Product Change Notification: E-19-000491

PCN Date: 01-MAR-19

PCF PCFL PCFN relay

PCF PCFL PCFN relay card component modification.

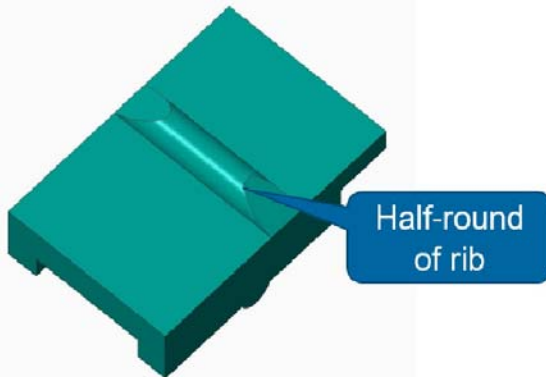
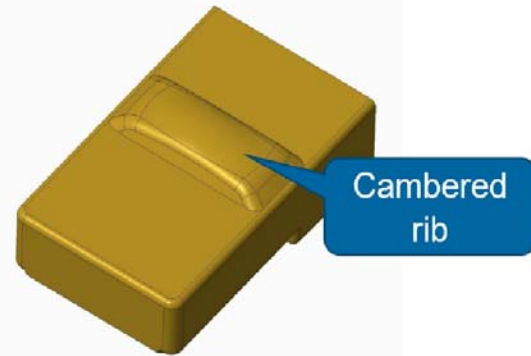
Product Improvement. TE will change the rib of card from current half-round to cambered of PCF PCFL PCFN relay as a assembly process improvement in the product line of TE plant(attached the comparison pictures). No relay function impact.
